Yarnton, Cherwell

Application Comments Response Note

162751A/N03

Planning Application 21/03522/OUT

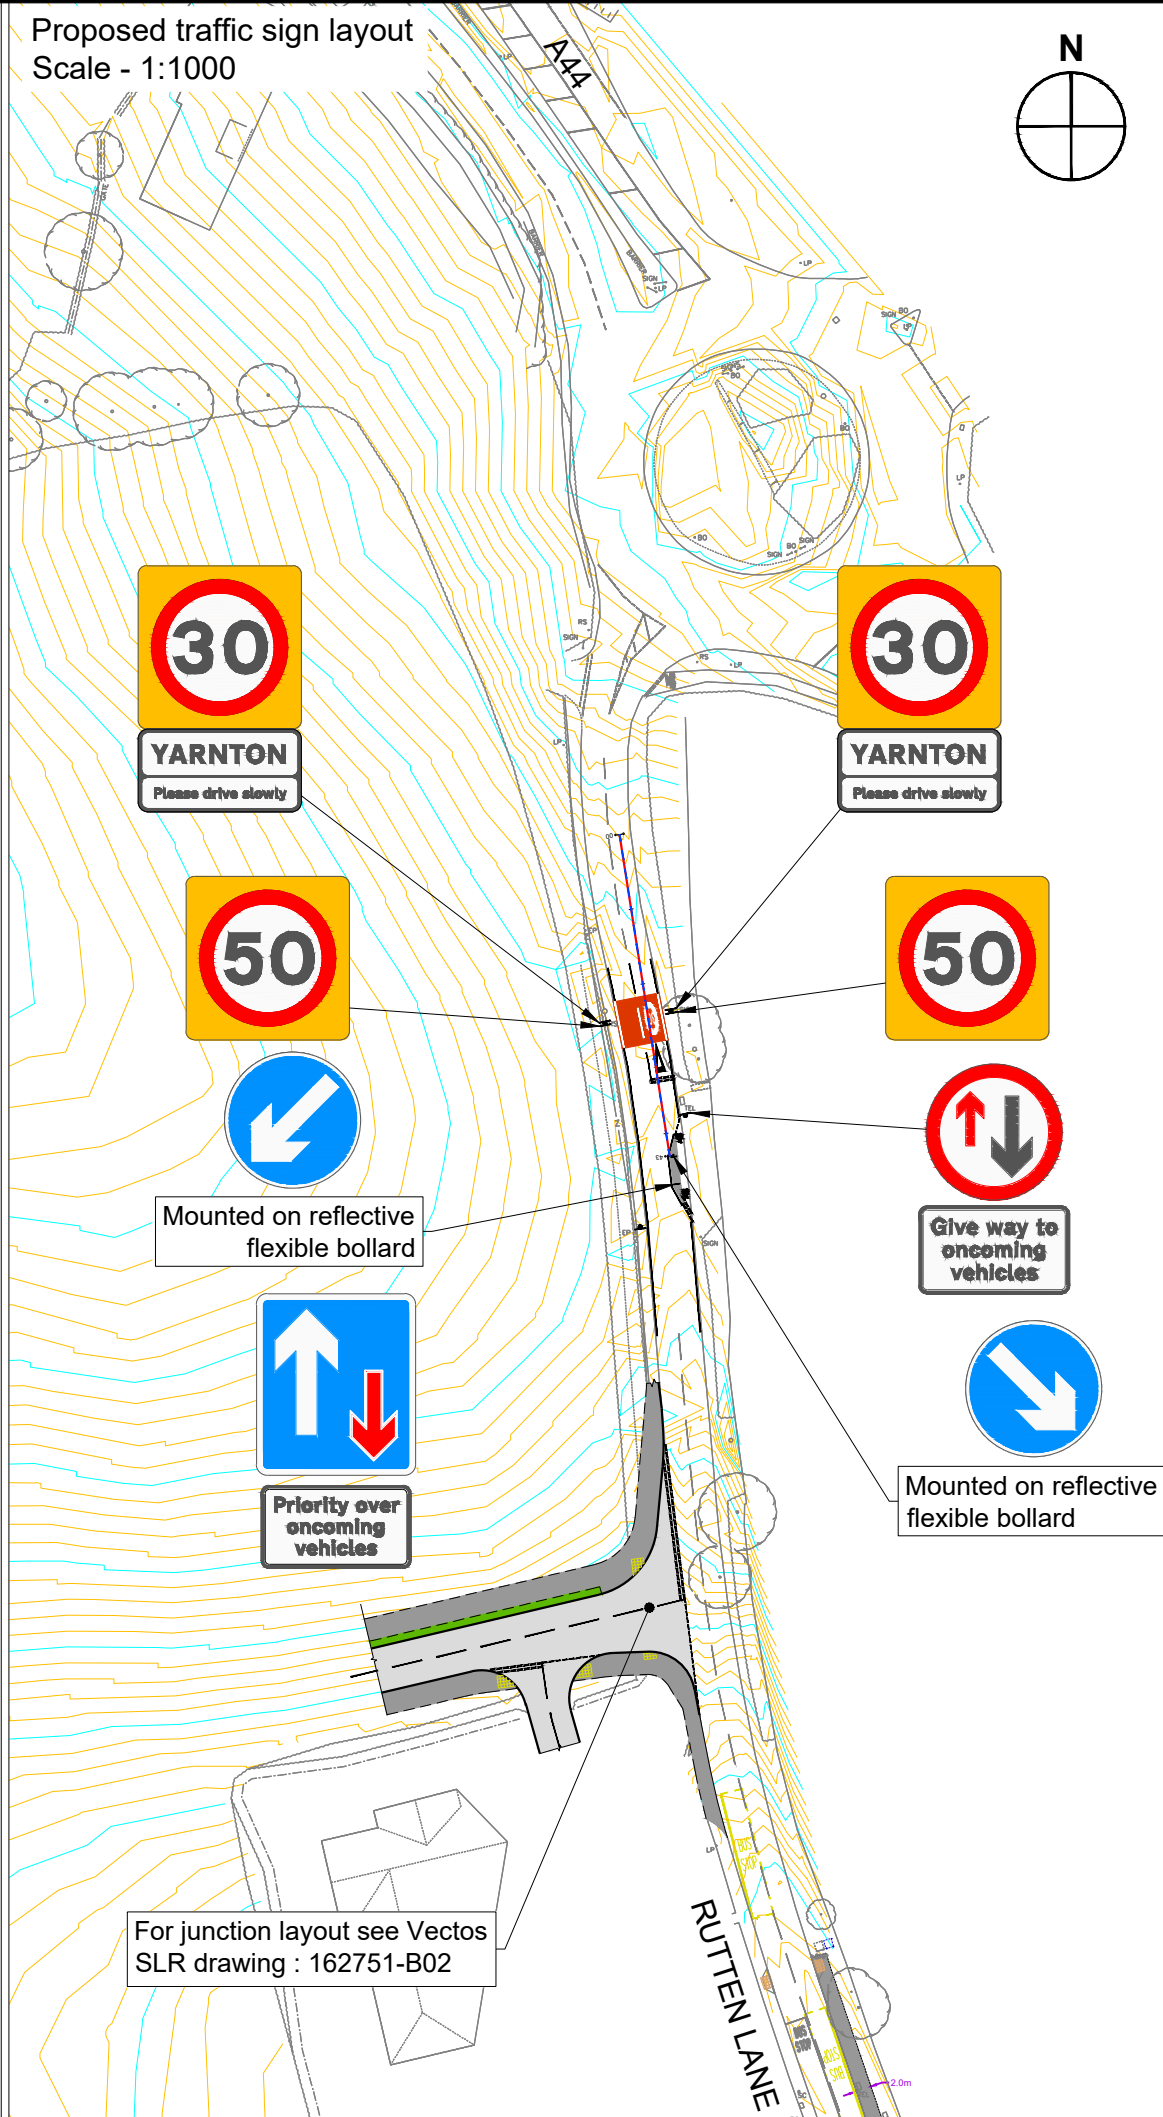
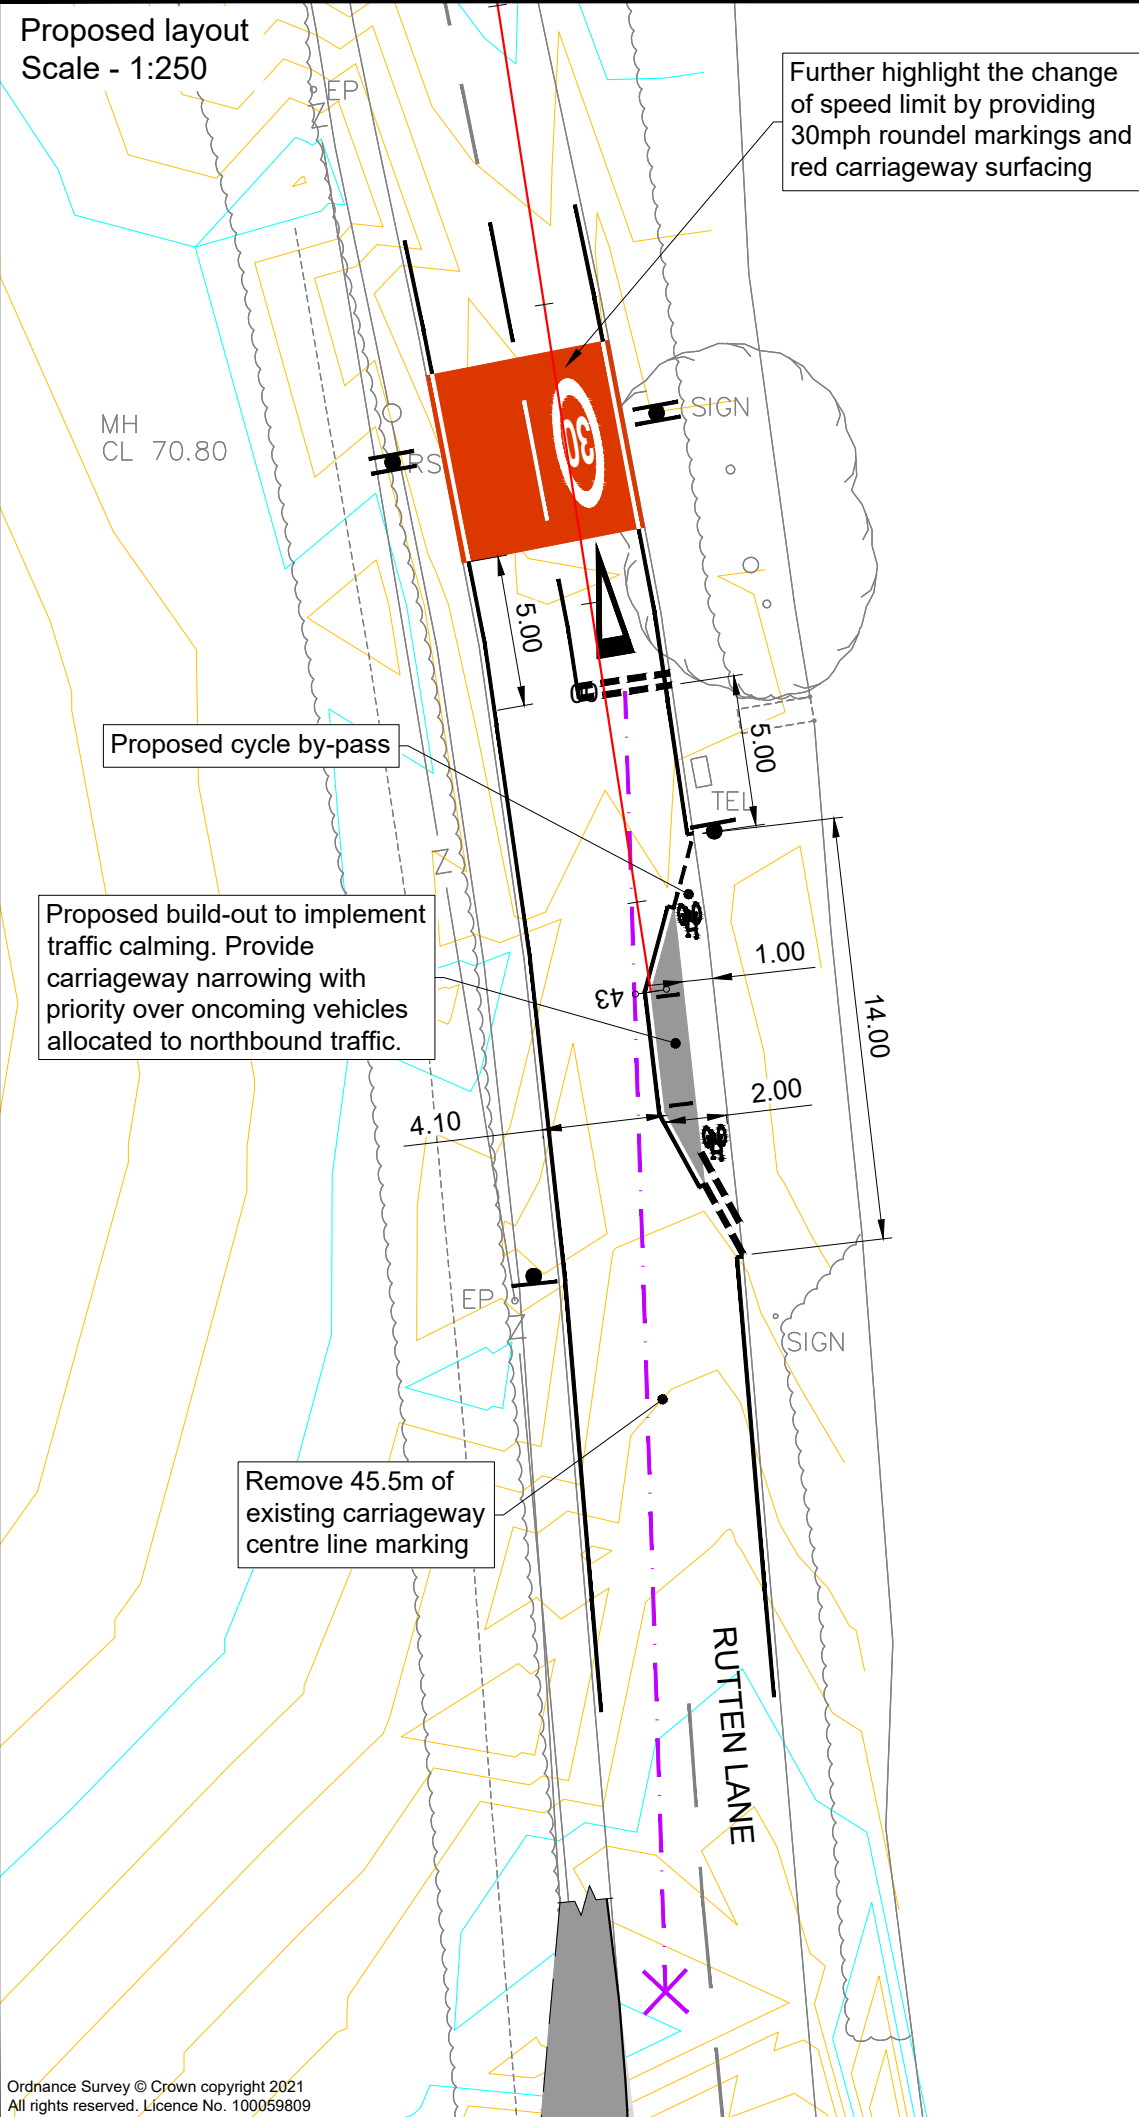
- Drawing 162751/B01/AT01 Rev D – tracking of the A44/ Begbroke Science Park access;
 - Drawing 162751A/PD02 Rev A – visibility splays in the vertical plane which show that the gradient of Rutten Lane is not a constraint to achieving suitable visibility, as contended by YPC;

addition, enclosed Drawing **162751A/PD02 Rev A** shows that there is suitable visibility, thus responding to YPC's concerns on this point.

13. It is equally considered that the information provided on the **Drawing 162751A/PD02 Rev A** provided at **Appendix C** addresses the comments made by YPC. The inclusion of a traffic calming/gateway feature will help reduce the occurrences of vehicles disobeying the current posted speed limit, which has been cited by YPC as a concern. **Drawing 162751A/PD01 Rev B** also confirms that the location of the build out is such that suitable forward visibility is achieved in both directions.
